Appendix VII - Agency Coordination

Annex A: Draft Fish and Wildlife Coordination Act Report

**WEST SHORE LAKE PONTCHARTRAIN CONSTRUCTION PROJECT,
Hurricane and Storm Damage Risk Reduction in Ascension, St. Charles, St.
James, and St. John the Baptist Parishes, Louisiana**

FISH AND WILDLIFE COORDINATION ACT REPORT

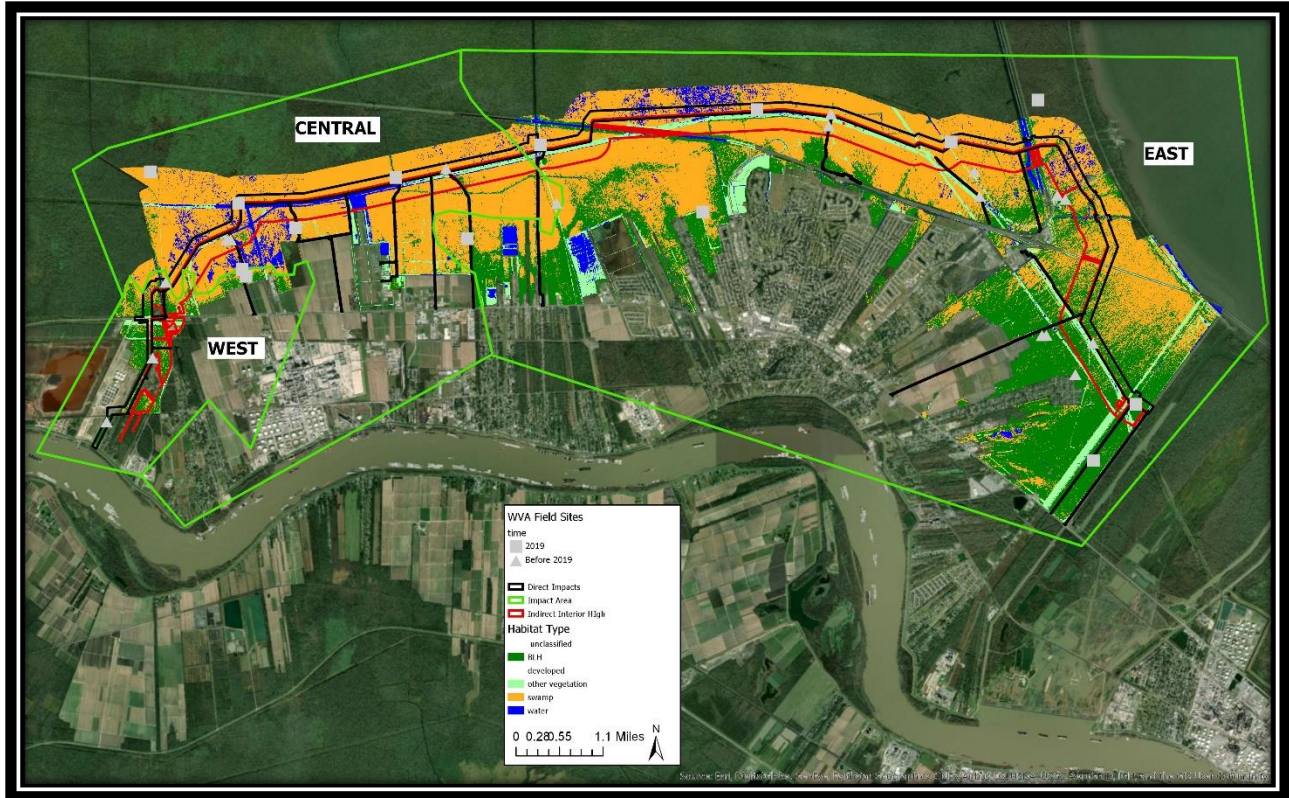
Impact areas used for evaluation are shown on Figure 2.

The Indirect Low impact area was selected because the HET assumed that slight development impacts would occur in this area. These impacts were captured by WVA variables V5-V7 (size of contiguous forested area, surrounding land uses, and disturbance). No hydrology impacts were anticipated in this area (Figure 2).

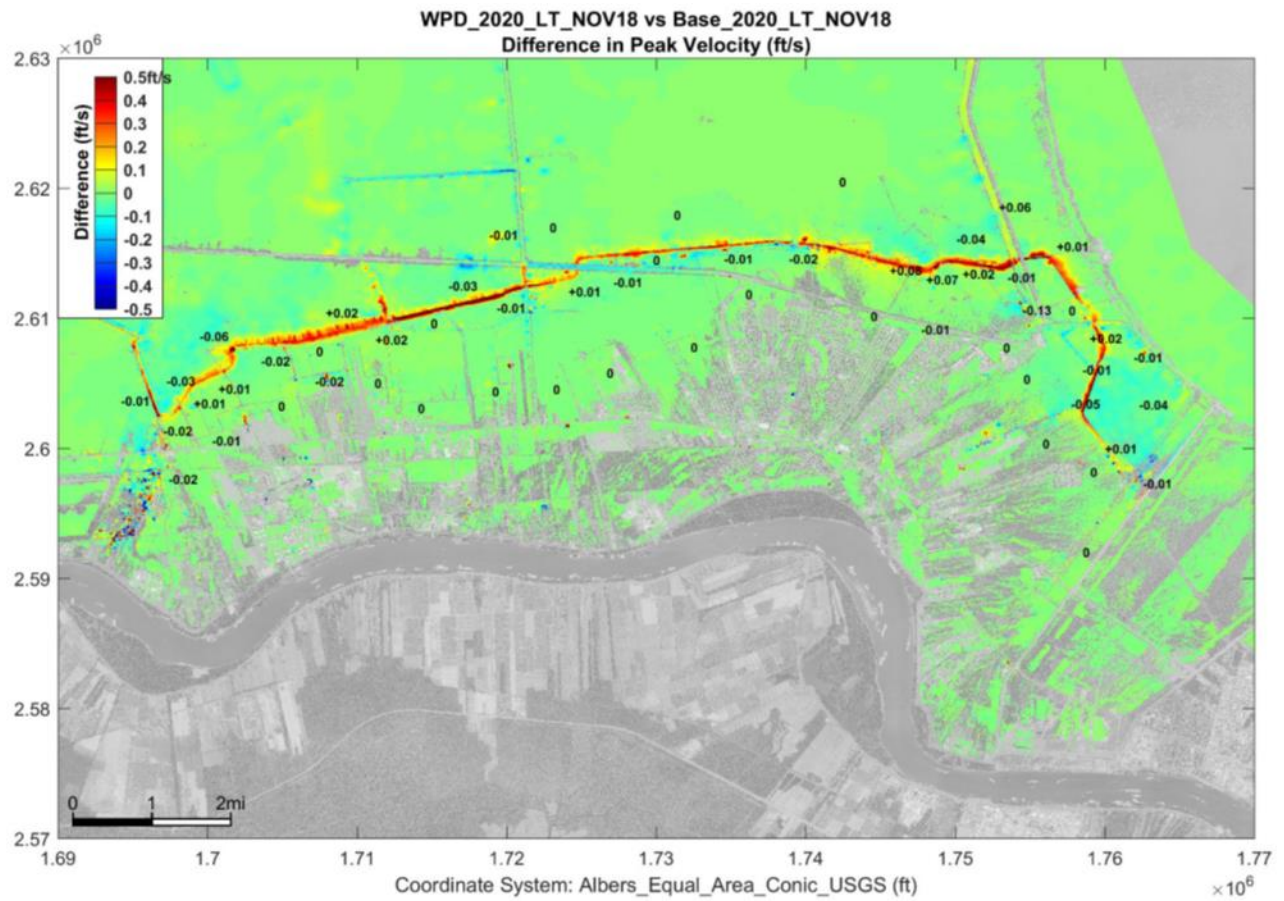
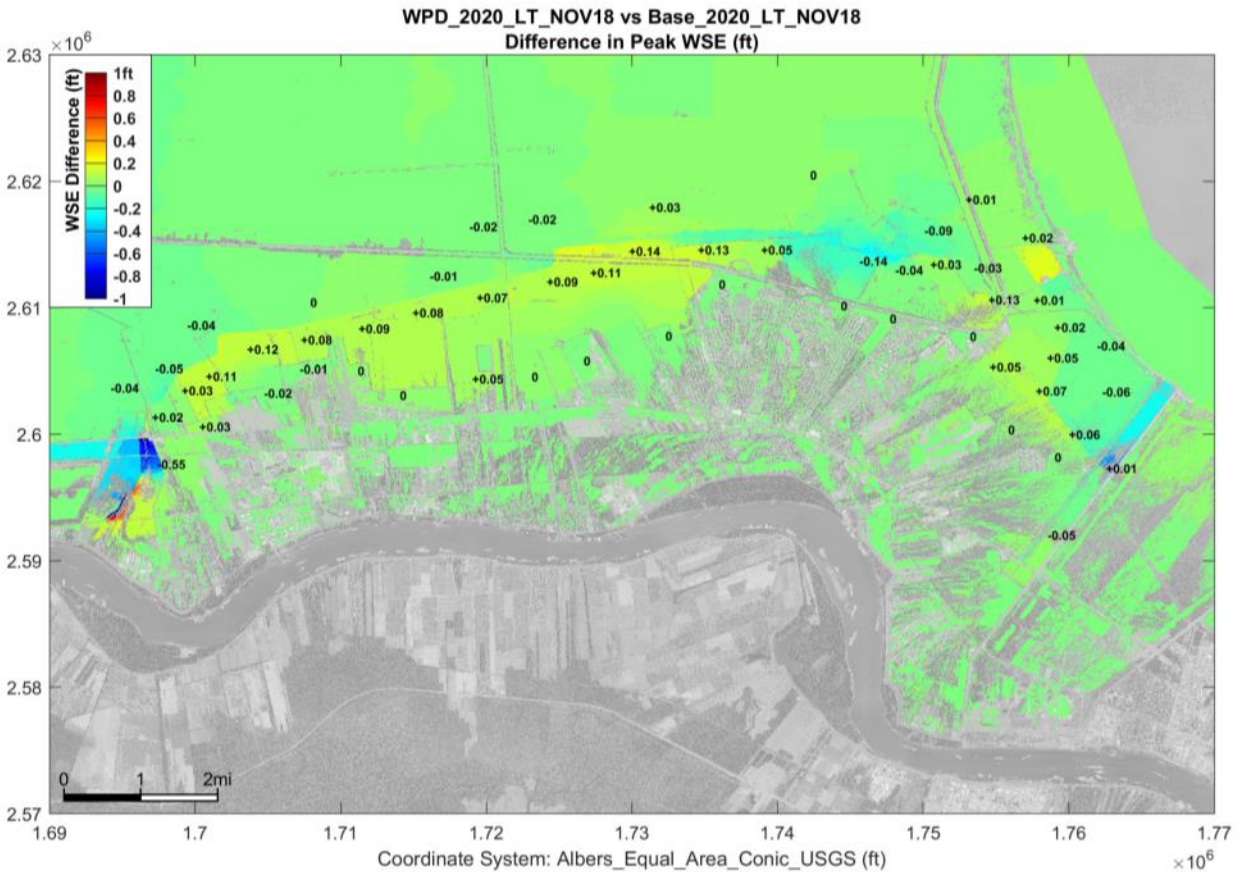
HEC-RAS 2D modeling (both with and without an intermediate RSLR) revealed that a slight increase in inundation occurred in some locations near the levee alignment. Indirect impact areas were determined based on the project-induced hydrology changes. The Indirect Exterior and High areas were delineated to capture the project-induced hydrologic changes (Figures 2, 4 and 5). The Indirect Low impact area was not anticipated to have hydrology impacts (Figures 2, 4 and 5).
